Re: FortisBC Inc. (FBC)

Application for Approval of a Certificate of Public Convenience and Necessity for the A.S. Mawdsley Terminal Station Project (Application) ~ Project No. 1599424

Response to the British Columbia Public Interest Advocacy Centre representing BC Old Age Pensioners' Organization, Active Support Against Poverty, Council of Senior Citizens' Organizations of BC, Disability Alliance BC, and Tenant Resource and Advisory Centre (BCOAPO) Information Request (IR) No. 2

Updated Figure 3-2: Boundary and Similkameen Power Supply Single Line Diagram with the Addition of 42 Line

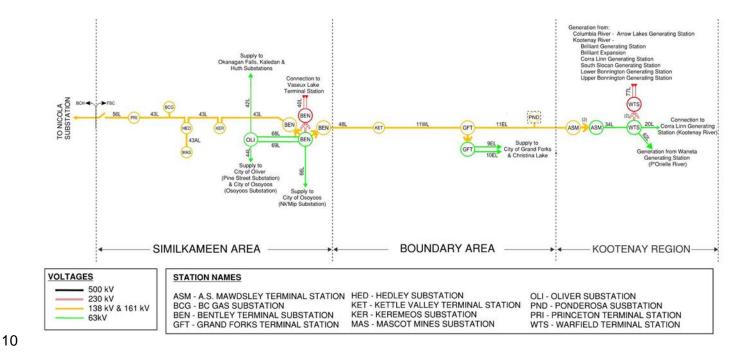
1 2			
3 4 5	26.2		e 42L referenced in the response to BCOAPO 1.1.6 does not appear on 3-2. Please provide a revised Figure 3-2 that includes 42L.
6 7		26.2.1	Please describe the nature of 42L (i.e., single or multiple circuit), its role and its supply capability.
8 9 10		26.2.2	Please comment on the capability of 42L to meet the increasing Boundary and Similkameen area loads.
11	Response:		
12	Please refer to	o the resp	ponse to BCOAPO IR2 26.1.
13 14			
15 16 17 18 19	26.3	make-u	rovided in the response to the preceding question, please describe the p of the 200 MW of supply capability to the Boundary and Similkameen en both ASM transformers are not available.

- 2. 40 Line (from the Vaseaux Lake Terminal Station); and
- 3. 42 Line (from the Vaseaux Lake Terminal Station via Huth to the Oliver Substation). 42 Line is a redundant loop configuration and depending on system load, generation dispatch, and system configuration, 42 Line can supply north to the Okanagan Falls, Kaledan and Huth regions or can feed south to the Oliver region.
- The following updated Figure 3-2 shows the addition of 42 Line, which is an approximately 36 km transmission line at 63 kV from Huth to the Oliver Substation.

The supply capability of 42 Line, set out in the following table, is able to meet the increasing Boundary and Similkameen load for the current planning horizon.

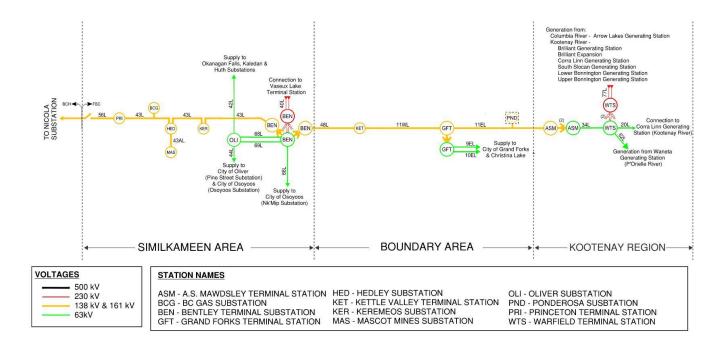
20 21 22 23		to F	h respect to the last paragraph in the Preamble, please identify (with reference Figure 3-2 with the inclusion of 42L) the "one source" that would be used to feed Boundary Region if the 11 Line is open and its capability.

- The "one source" referenced in the preamble to this IR depends on where the 11 Line path is opened.
 - If 11E Line is opened, then the remaining line serving the Boundary region is 48 Line, which has a summer emergency capacity of 222 MVA.
 - If 48 Line/11W Line are opened, then the remaining line serving the Boundary region is 34 Line, which has a summer emergency capacity of 261 MVA.
- 31 Please refer to the updated Figure 3-2 below for reference.
